November 10, 2021

RE: BLOCK 21

I reviewed the drawings, and evaluated the site context. My comments on the plans and elevations for this project are as follows:

EAST THIRD AVENUE AND SOUTH CLAREMONT STREET CORNER

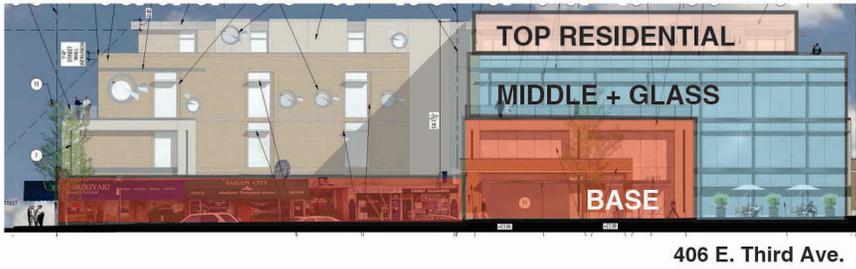
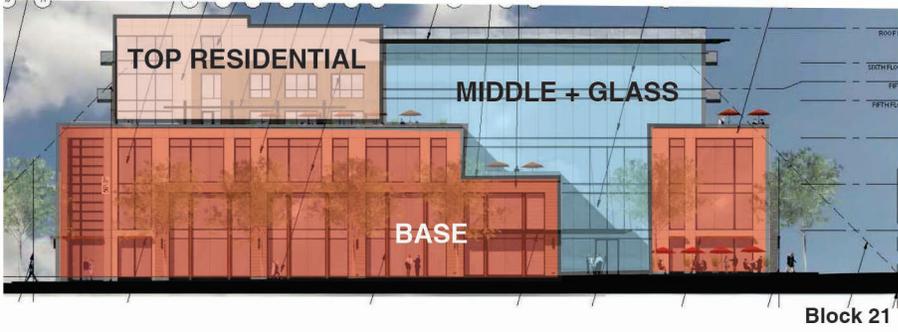
6. A mix of one, two and three bedroom units would be desirable.
7. Would like to see the unit types broadened to allow opportunities for families.
8. The bevel at corners didn't seem right - need to be reworked.

9. Corner designs are incongruent with the rest of the design.
10. Worry about sight lines for pedestrian safety at the garage entry/exit ramp.
11. Architectural design overall very good, but somehow overbearing.

Planning Commission concern that beveled corners did not blend well with the rest of the design

12. Consider adding more landscaping at the small plaza at the corner of East Fourth Avenue and South Delaware Street.
13. Some planning commissioners were concerned that the two rounded corners did not relate well to the rest of the design. I personally didn't find them a problem because rounded corner entries in downtown buildings are common - see photos below of nearby commercial corner one block east of this site and one at Santana Row. I do note that one of the angles corners is labeled as an entry to ground floor office space while the other is not. If staff and the planning commission feel strongly about this matter, a squaring off of these corners with an inset rectangular landscape space would not be out of character with the the overall design of the building

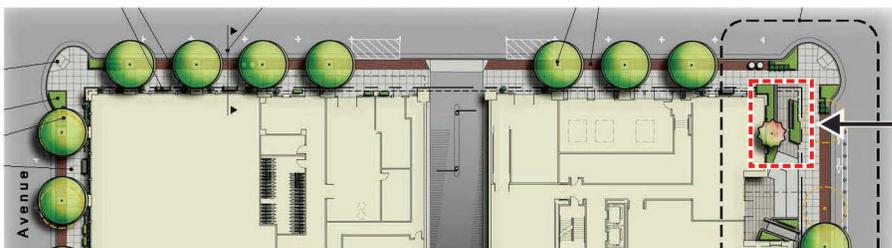
3. The landscape plan shows a well landscape corner plaza adjacent to the main office lobby, while the sketches appear to show a more active use.

This shows passive open space while sketches show active space which is it?

3. Clarify the intent for use and landscaping for the plaza adjacent to the office entry.
4. Provide street front awnings or canopies to better relate to the adjacent pedestrian areas.
5. Extend the darker wall facade with recessed window up to the sixth floor consistently around all facades.
6. Reduce the depth of the projecting private balconies to better integrate them into the overall design, wherever possible. This is often achieved by inseting the balconies, as shown on the photo below, or adding area to the common residential open space.

Residential Lobby location on utilities frontage less than desirable

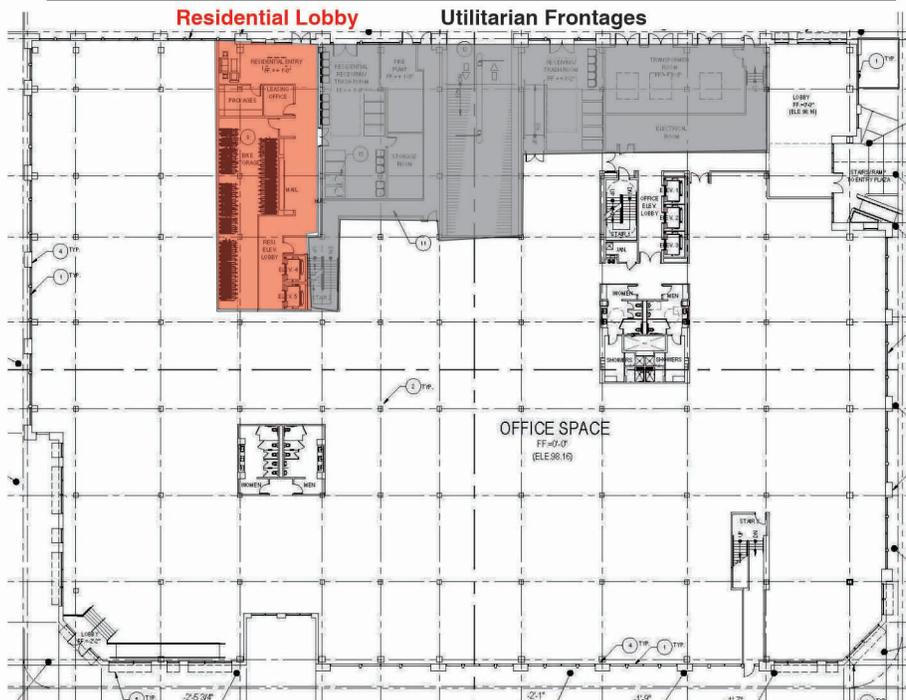
4. Planning commissioners' initial reaction was that they liked the design, but that it seemed a little overbearing and cold. They also were concerned that the design was lacking in overall design unity, and might not relate well to either the adjacent new developments or the adjacent neighborhood.
5. The project's residential lobby entry is located on South Claremont Street, adjacent to all of the building's utilitarian spaces and garage entry. This doesn't seem like a very pleasant lobby location, and not one to be thought of as a prestigious address.

7. Add a projecting roof canopy to the residential portion of the structure.
8. Reverse the color tones of the second and third floor masses to give more visual emphasis to the two story mass
9. Consider relocation the residential lobby entry away from the garage entry and adjacent utilitarian frontages.

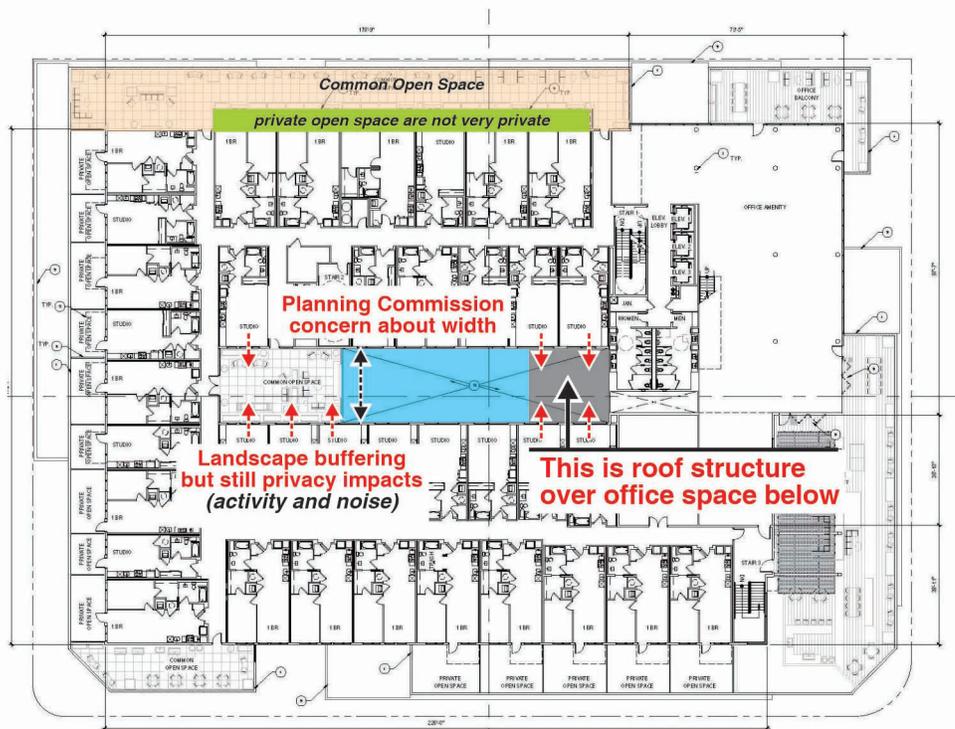
- The residential balconies are quite deep for this type of project, and add to the lack of visual unity expressed by the commission.
- The planning commission expressed concern for pedestrian safety related to the garage entry and exit ramp, a condition that might be compounded by the adjacent location of the residential lobby.

- At least one planning commissioner expressed concern about the width of the open atrium on the residential floors. There is one other issue related to the residential common open space adjacent to the atrium. While the landscape plan shows plantings around the edge of the space to provide some visual buffering of the adjacent residential units, there may still be issues of visual privacy and noise, Note that the plan drawing failed to show the office roof structure that intrudes into the atrium space shown.

- There is a mixing of residential common open space and private resident patios which may have some visual and noise impacts on the adjacent residential units.

10. Resolve the privacy and landscaping of the spaces adjacent to the open atrium on the fourth floor.
11. Reevaluate the mix of residential common open space and private open spaces. One option would be to move this common open space to the roof, where the code allows, which is becoming quite common on larger residential projects.
